Virginia Dale Rest Area - US 287 MM 383.5 Elevation ≈ 7034'

CDOT Region #4

Summary Observations

Vending Machines and Visitor Information

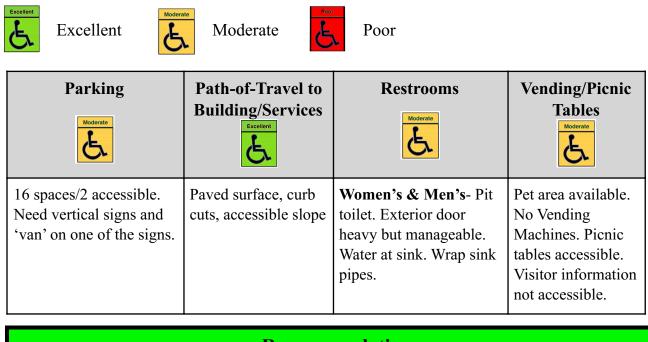
There are no vending machines. The visitor information sign is not on an accessible path.
